Subject: Crystal River Unit 3  
Docket No. 50-302  
Operating License No. DPR-72

Enclosed are three (3) originals and forty (40) copies of Technical Specification Change Request Nos. 50 and 51, requesting amendment to Appendix A of Operating License No. DPR-72. As part of this request, proposed replacement pages for Appendix A are enclosed.

### Technical Specification Change Request No. 50 [Appendix A]

## Technical Specification Change Request No. 51 (Appendix A)

FIGURE 6.2-2 FACILITY ORGANIZATION

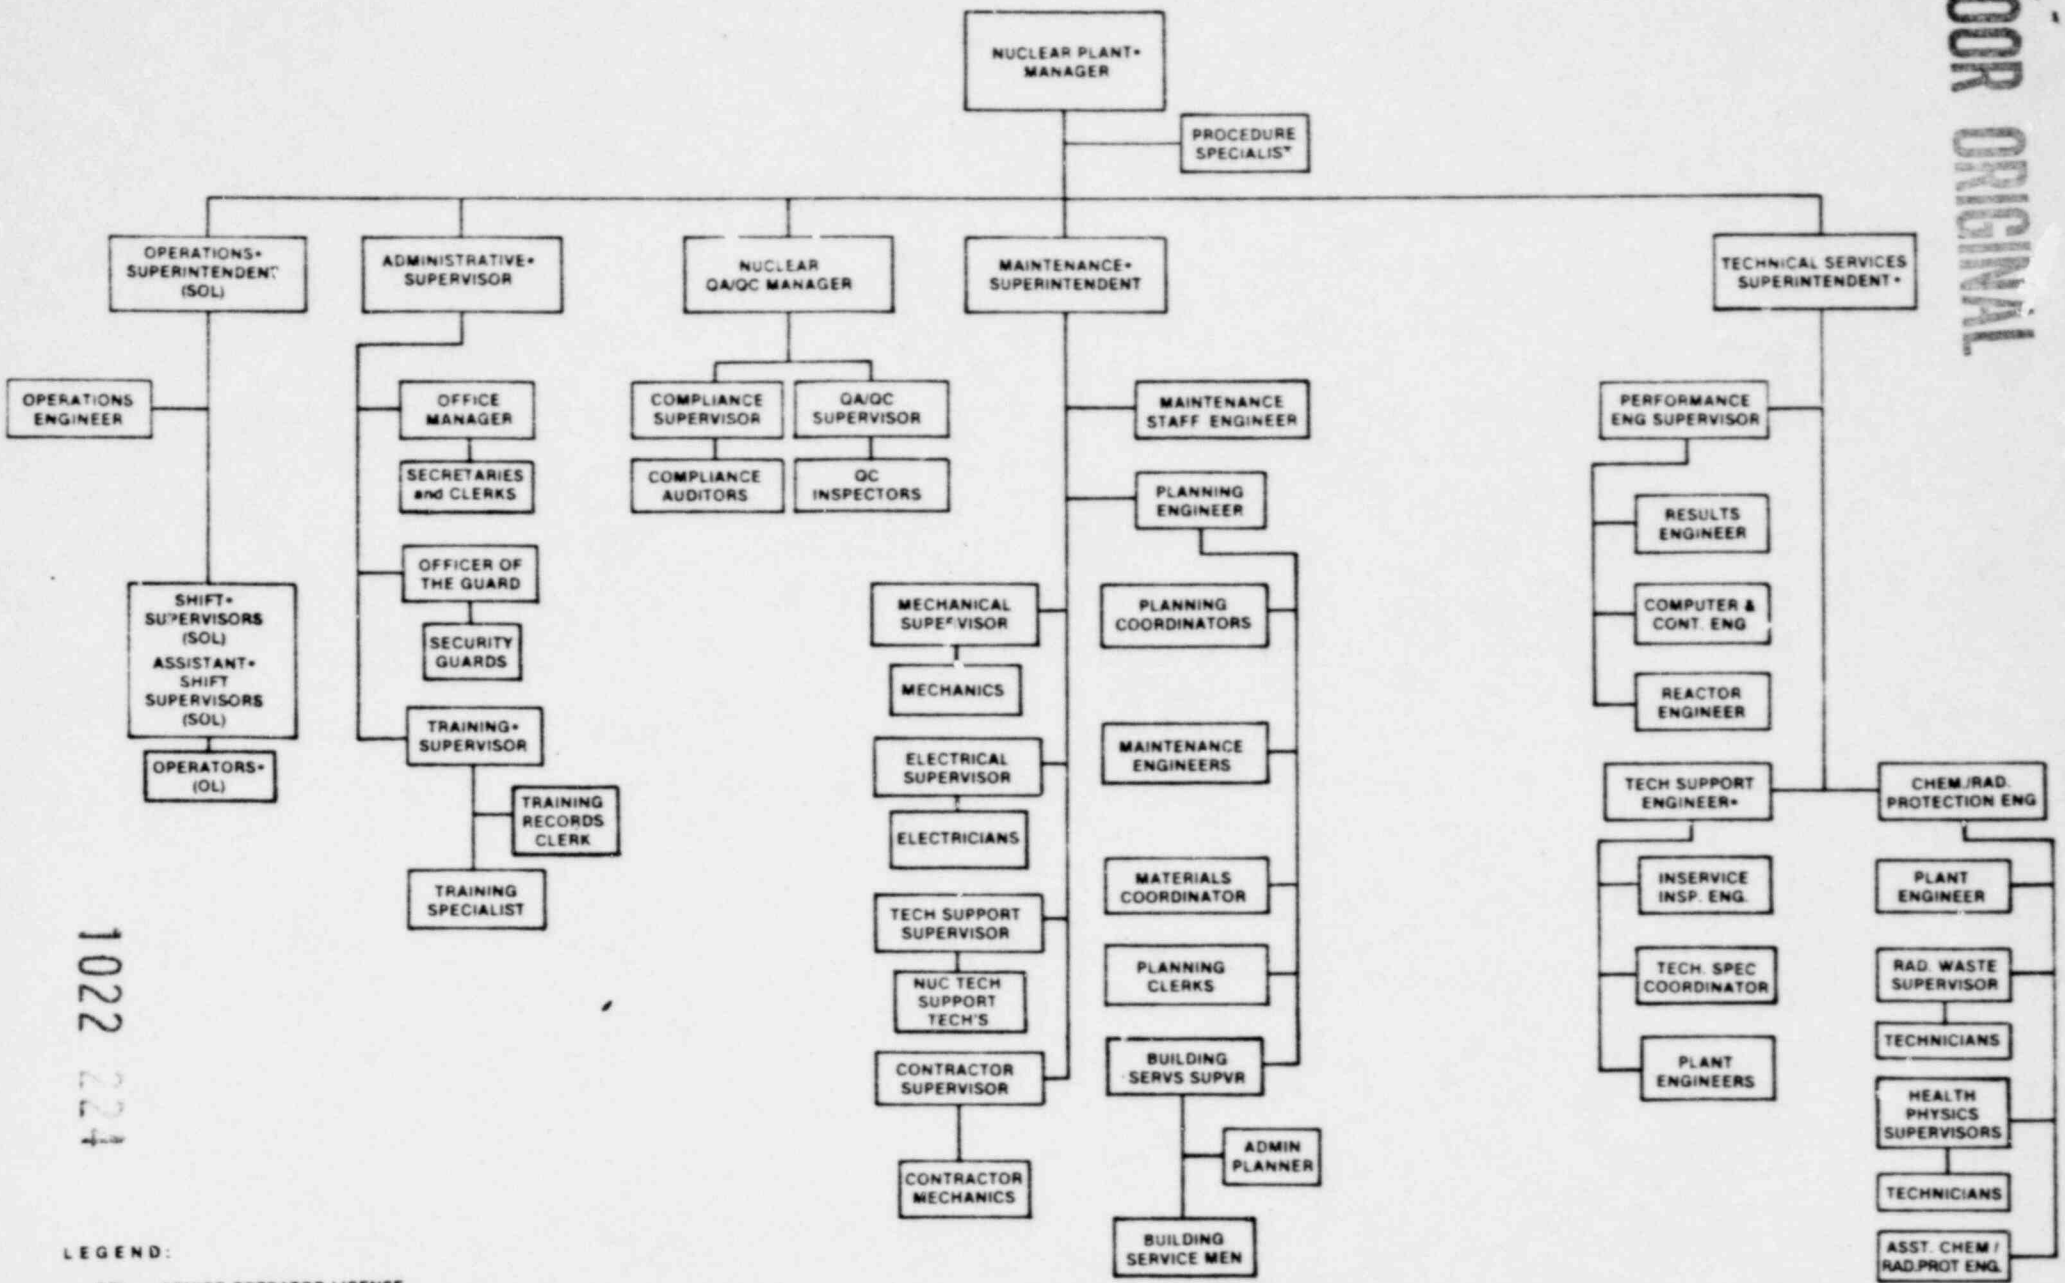
Replace page 6-3 with the revised page 6-3.

Realignment of the QA/QC group at Crystal River Unit 3. This organizational change consolidates the Compliance Section and the QC Inspectors under a new position, Nuclear QA/QC Manager, which reports directly to the Nuclear Plant Manager.
